Re: Helix Micro Rebar Shop Drawings
1700 SW Merryman Dr
Lot 69, The Manor
Lee's Summit Permit #2018-2146

Apex Engineers, Inc. observed the plans for the proposed house at the address referenced above. The plans were evaluated for substituting Helix micro rebar for the foundation reinforcing steel. The recommendations and attached detail sheets shall be considered shop drawings for an alternative reinforcement design.

ALTERNATE REINFORCEMENT DESIGN/HELIX MICRO REBAR

1
H1.0
TYPICAL FOUNDATION WALL DETAIL
1/2" = 1'-0"

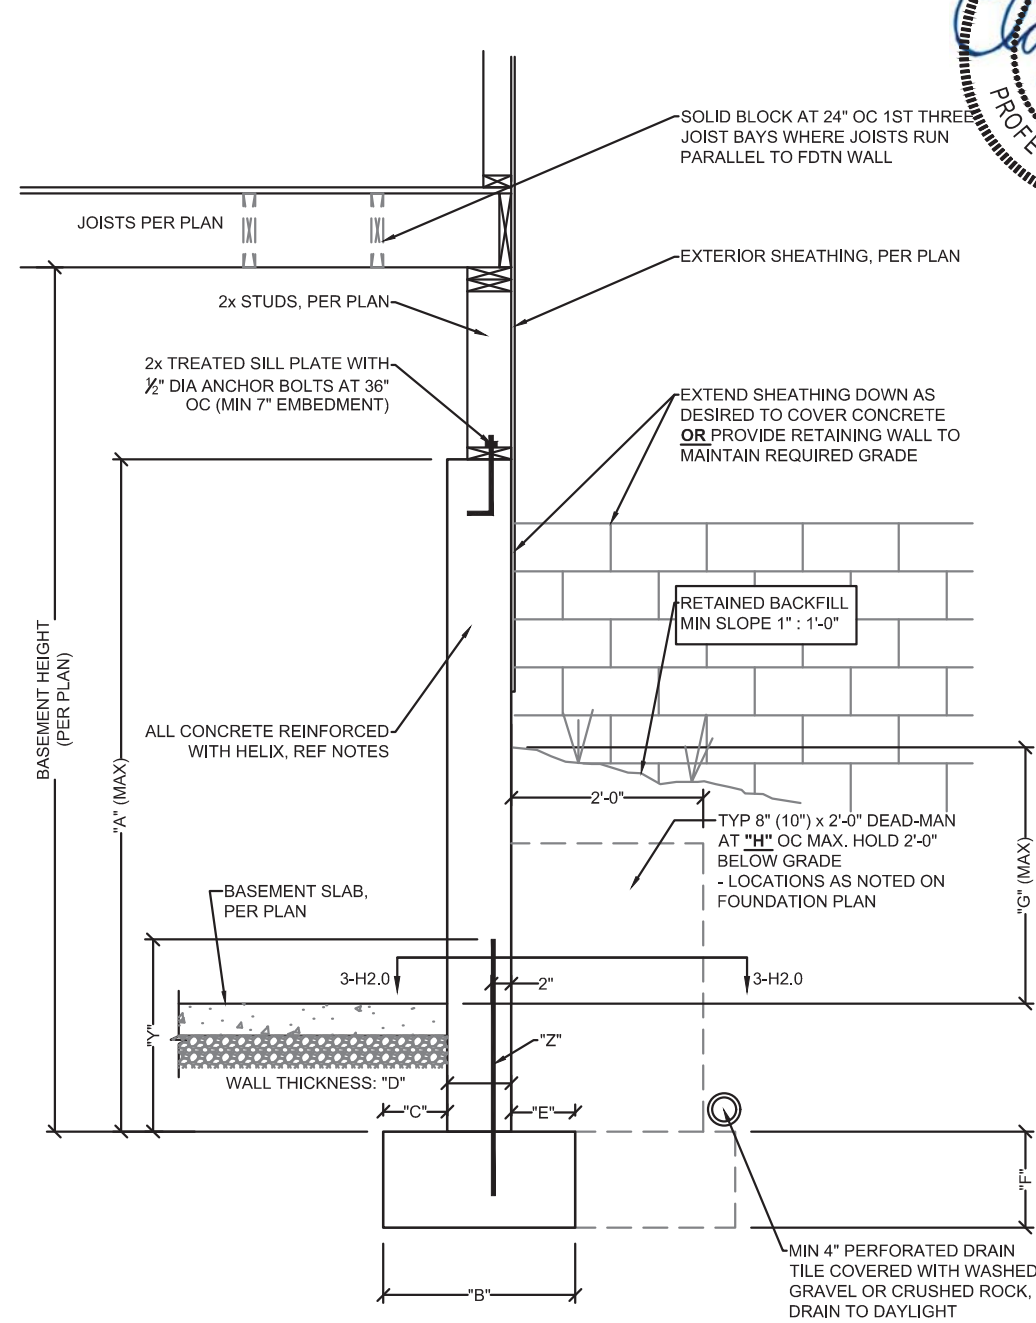
- Detail 1/H1.0 - Foundation walls, once completed, shall be laterally braced at the top by the first floor deck and at the bottom by the basement slab.

2
H1.0
TYPICAL 'DAYLIGHT' FOUNDATION WALL DETAIL
1/2" = 1'-0"

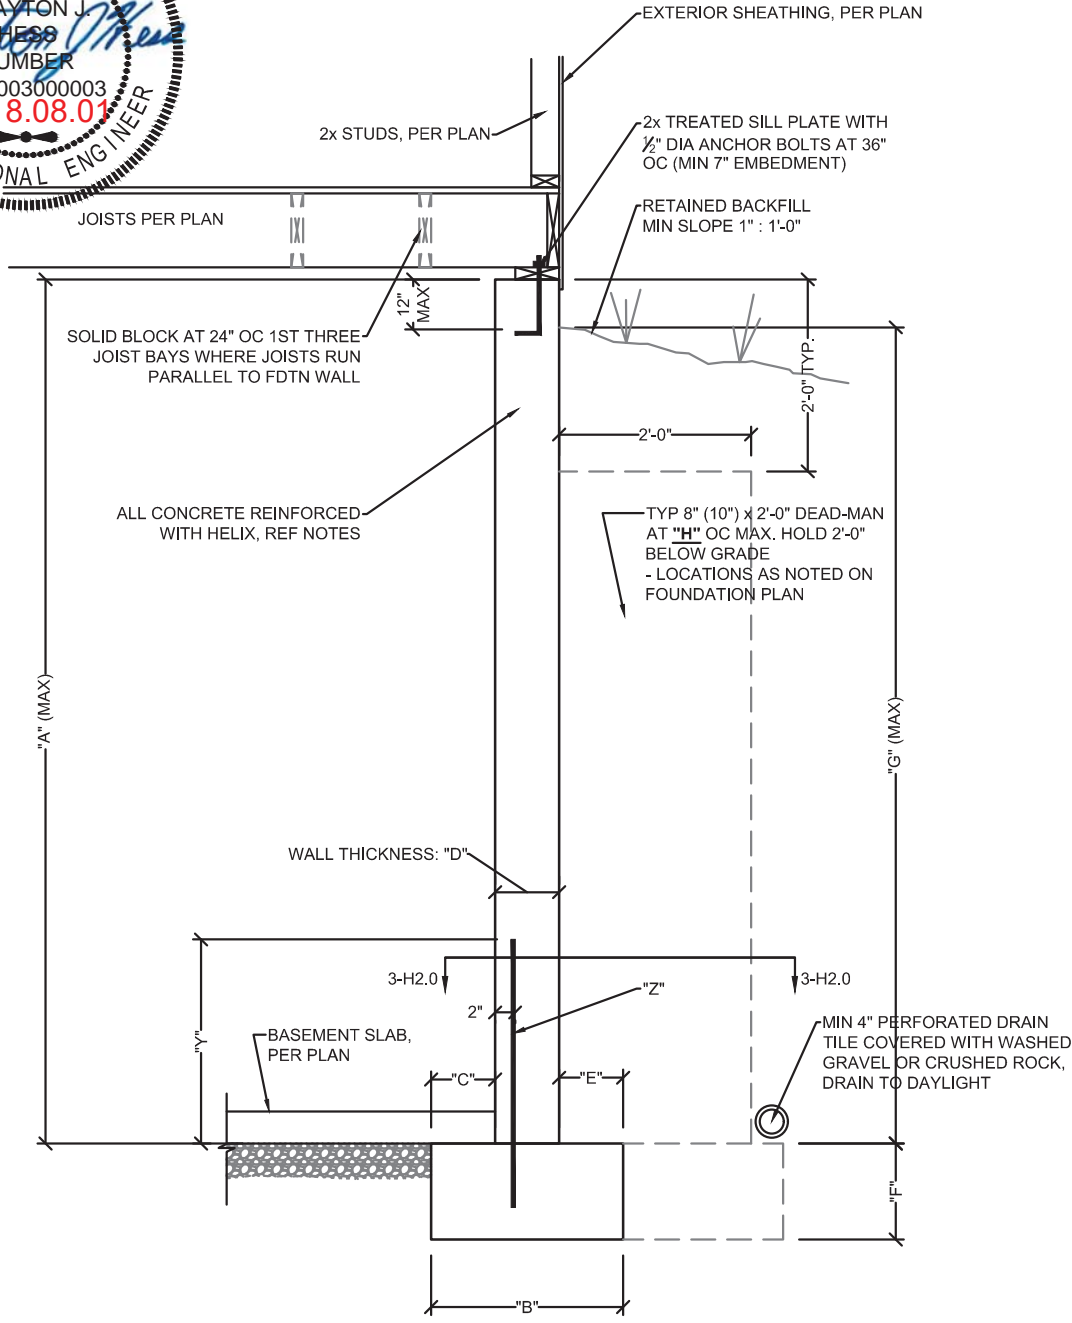
- Detail 2/H1.0 - Daylight foundation walls are concrete walls not directly connected to the floor joists via the sill plate. Daylight foundation walls shall comply with the following layout restrictions:

- Daylight walls greater than 4'-0" tall shall be bookended by corners, offsets greater than 2'-0", and/or return walls at a maximum spacing of 16'-0" on center. Return walls shall be placed per 3/H2.0

- Daylight walls greater than 6'-0" tall shall not exceed 6'-0" in length.
 - Daylight walls 4'-0" tall and less do not require return walls.
- Detail 3/H2.0 – Return walls shall be installed per plan. Additional return walls may be required to comply with the specifications above.

5 COLUMN PAD DETAIL
H2.0 1/2" = 1'-0"

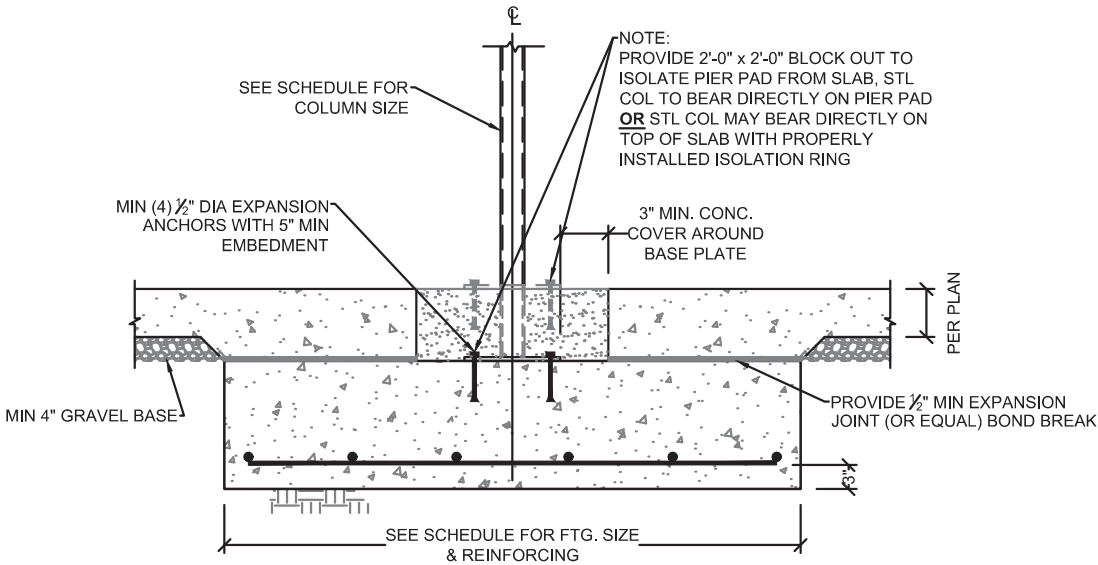
- Details 4/H2.0 & 5/H2.0 – Install corner reinforcing and column pads reinforcing per the attached details.
